# CHANGE OF TENSIONER PULLEY 55240 FROM MANUAL TO SEMI-AUTOMATIC TECHNICAL INFO NO. 1104

**Ford** | Transit  
Year of manufacture:  
from 12.2000

RUVILLE-No.	OE-No.
55240	1136426 1C1Q 6K254 AA

**Image 1:** 55240 semi-automatic tensioner pulley

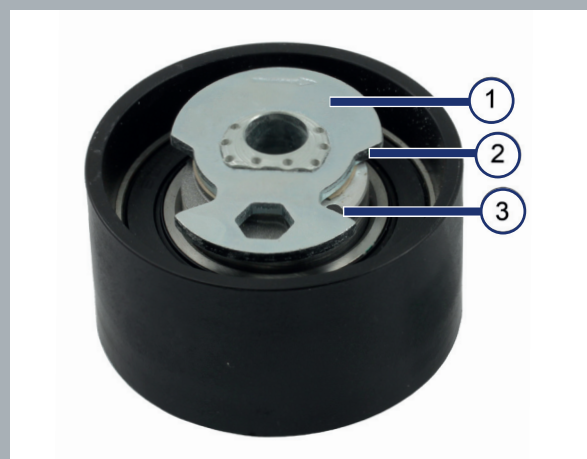
In the vehicle mentioned above, a manual tensioner pulley has been used in the timing gear to date. This part is being replaced by semiautomatic tensioner pulley 55240 and is also included in Kits 5524070 and 5524071.

The new tensioner pulley is fitted in exactly the same way as the old one. However, unlike with the manual tensioner pulley, the toothed belt is tensioned using a hexagon socket key.

To tighten the toothed belt, the clamping plate (1) must be turned using the hexagon socket key until the hole (3) is half-covered by the edge (2) of the clamping plate.
